ADDENDUM NO. 2

September 30, 2022

Woods Lake - A Magnet Center for the Arts Remodeling & Site Improvements

**Woods Lake Elementary
3215 Oakland Drive
Kalamazoo, MI, 49008**

SHEET NUMBER
M 802
18-519.00

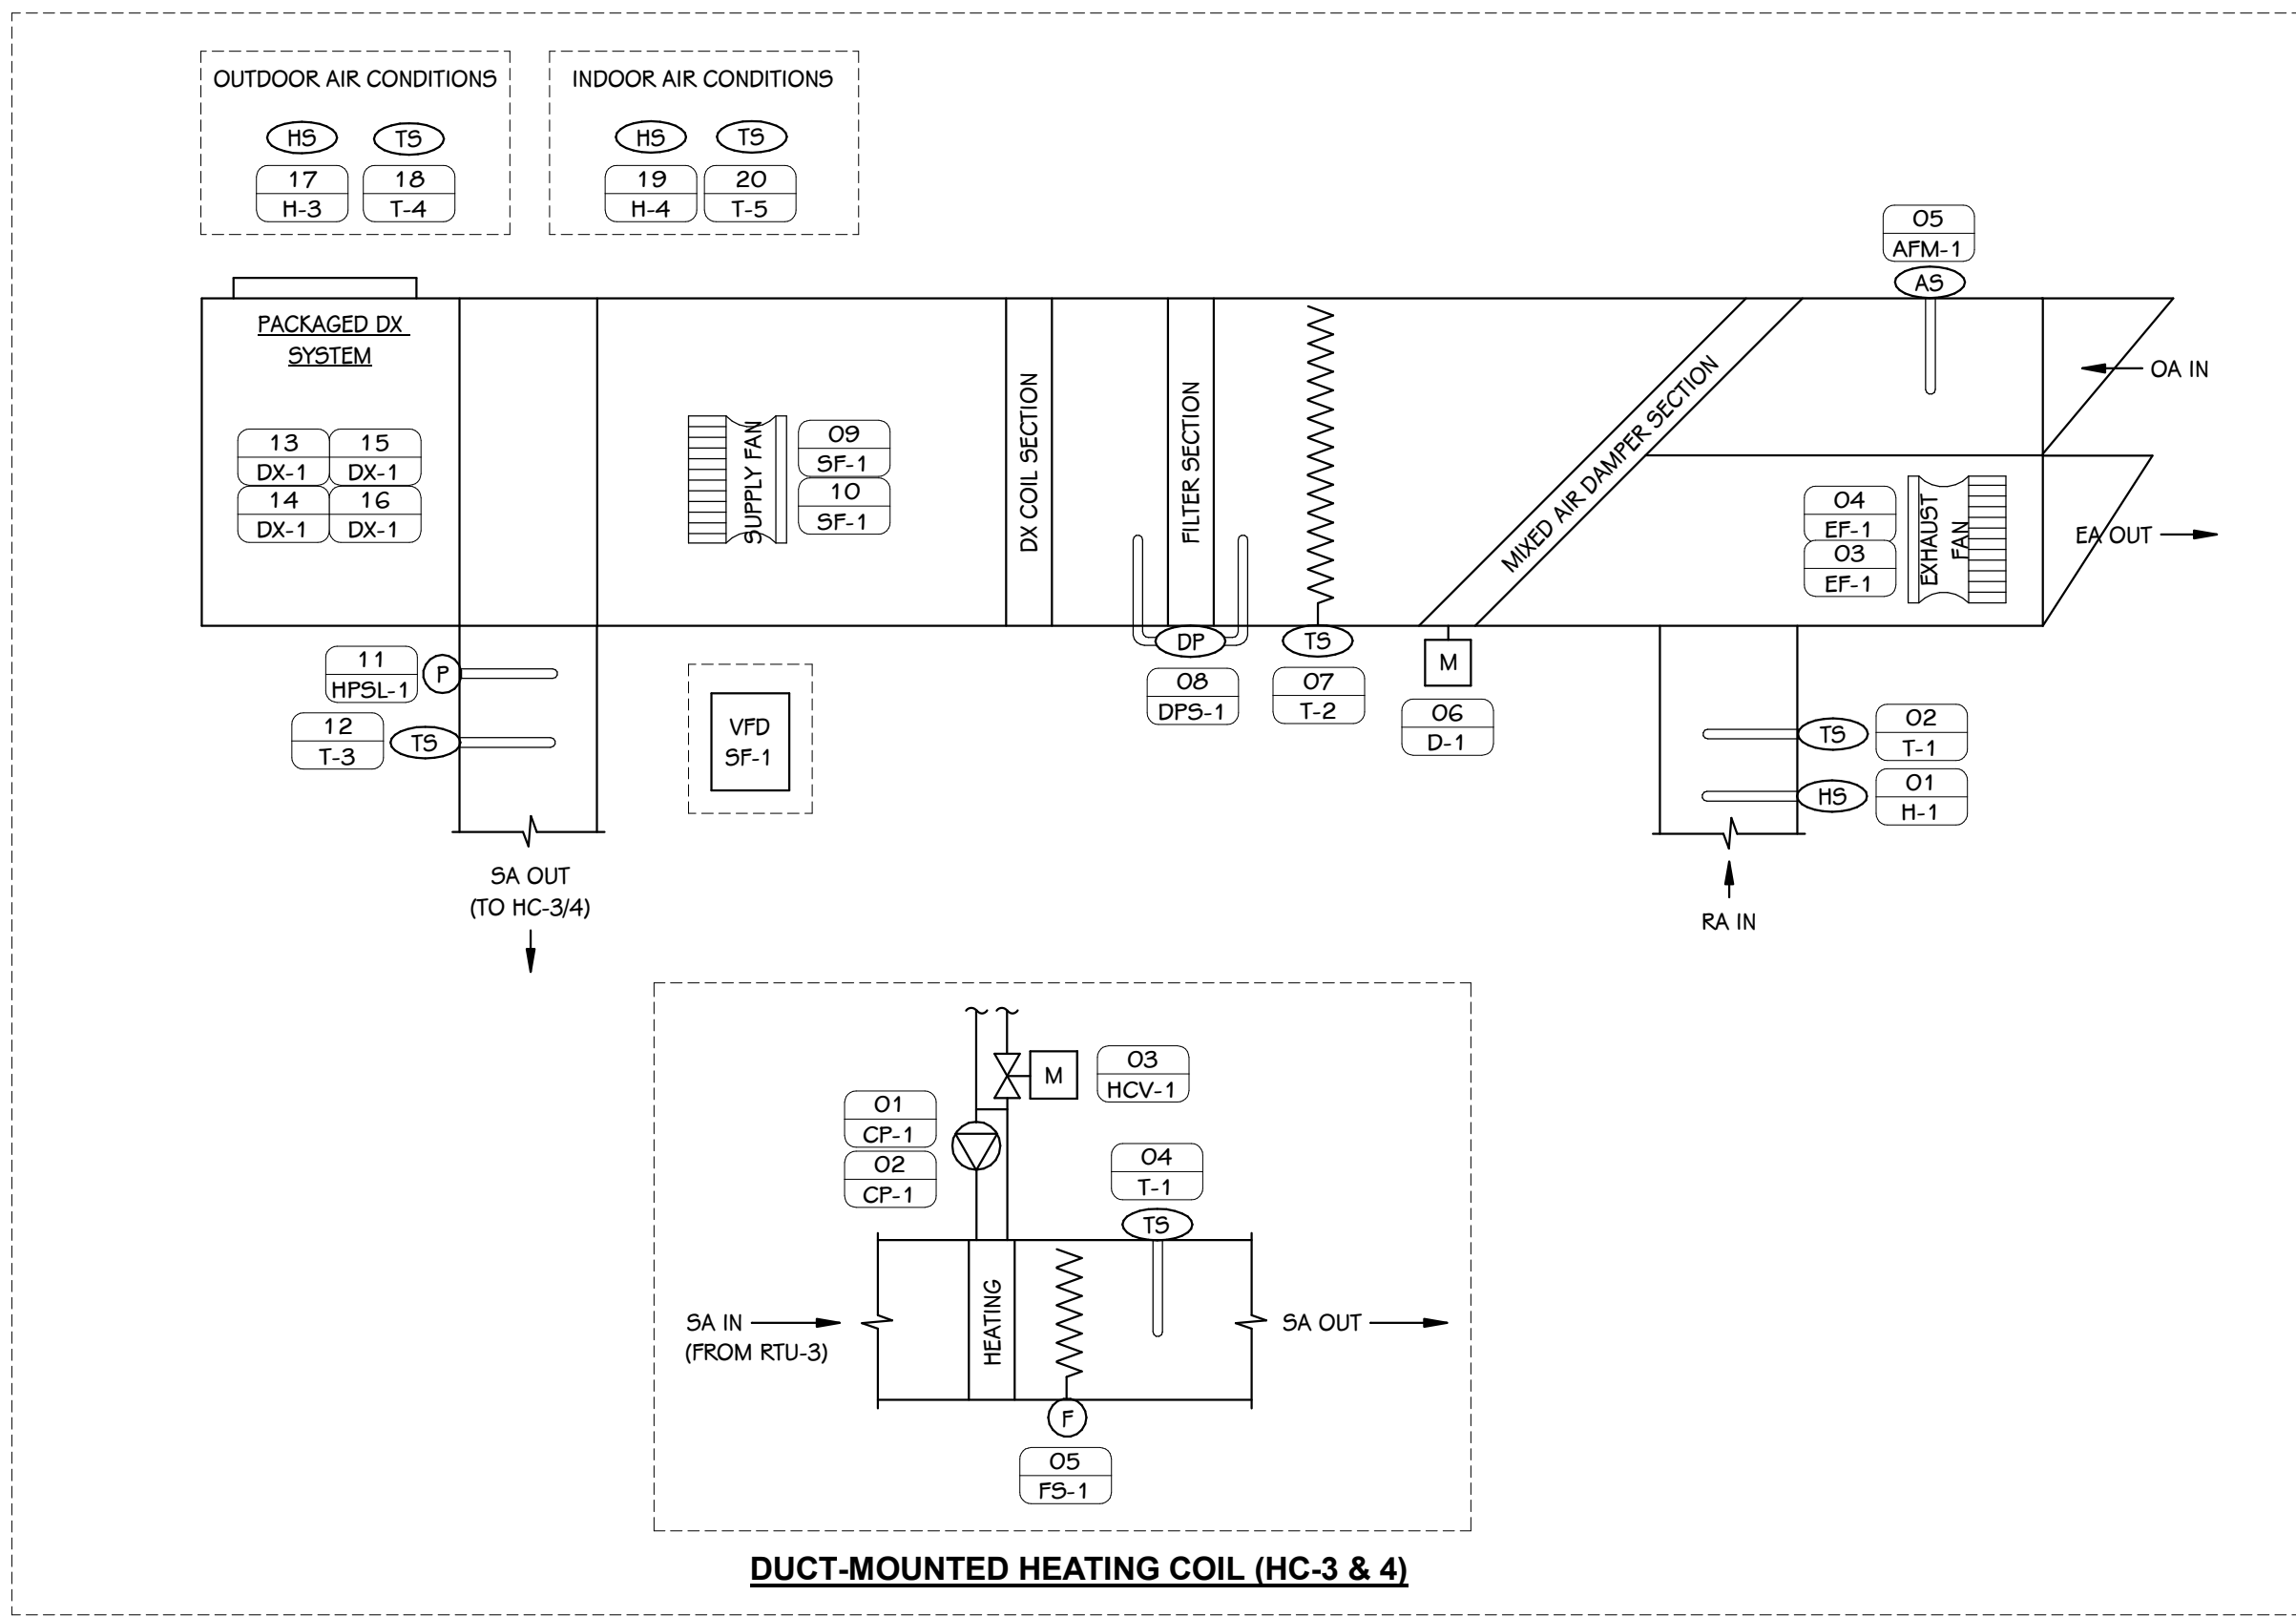
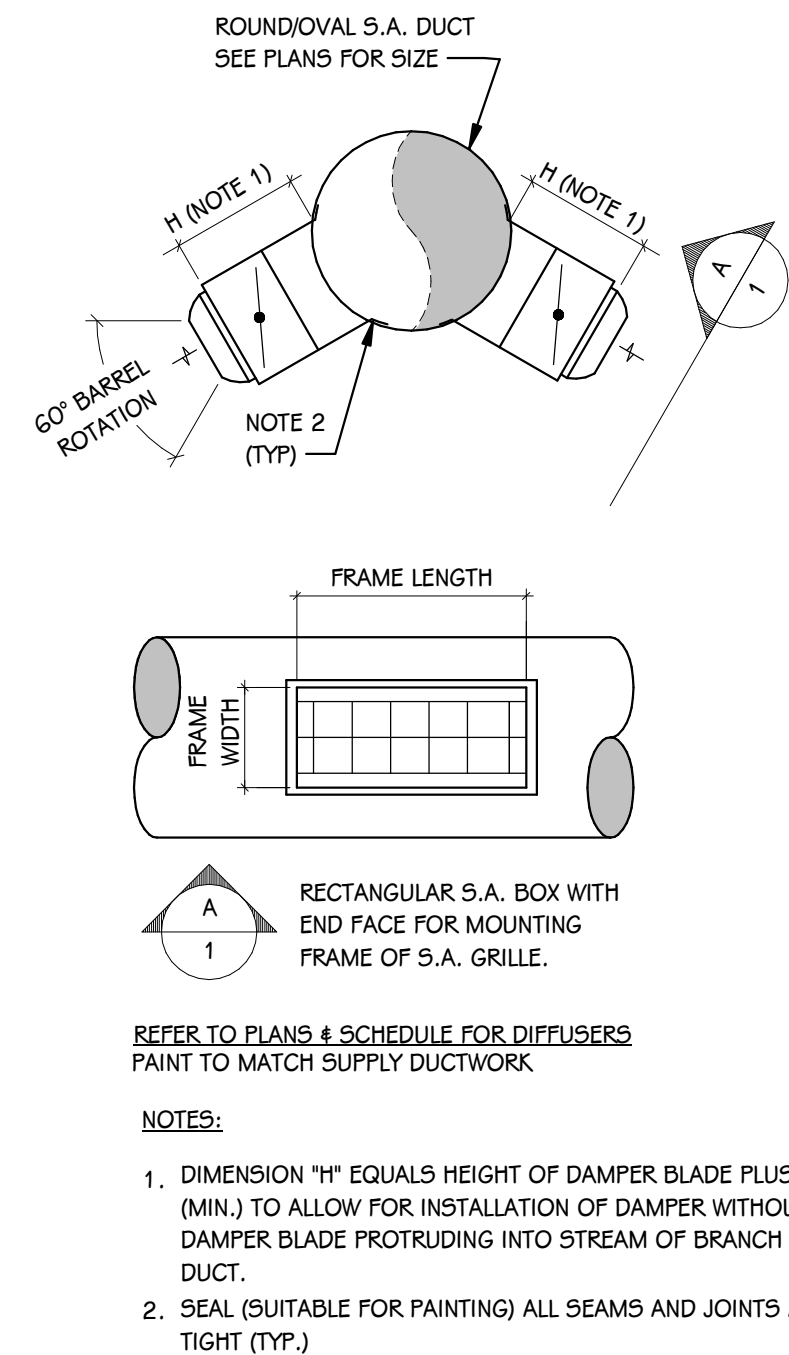
ADD-2 Item No. D-7 - Alternate Gymnasium AHU-3 Controls

Revised unit controls to be packaged controls. Modified sequence of operation to reflect this change.
